Access Compliance Report

Public Rights-of-Way

Intersection ID: 49102	Main Street: PROSPERITY_CROSSING_DR	Cross Street: BENFIELD_RD	Location: W
ADA ID: 0CA4D57419A7	Ramp Type: BlendTrans1	Initial Pass/Fail: Pass	Overall Compliance: No
		Severity Score: 0	
Codes/Mitigation Info/Possible Solution		Field Measurements/Component Compliance

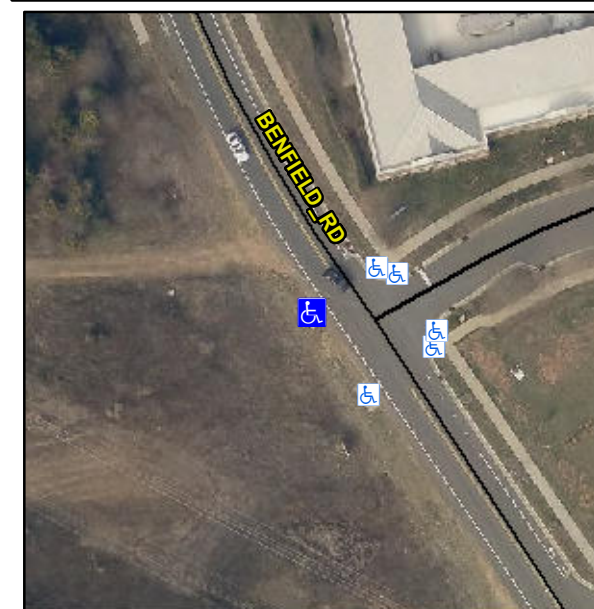
NO CURB, NO SW, DWS OS MEASURED TO ASP

R304.2.2-Perp, R304.3.2-Para, R305.2

Remove & Replace Curb Ramp With Two New Directional Ramps or Equivalent.
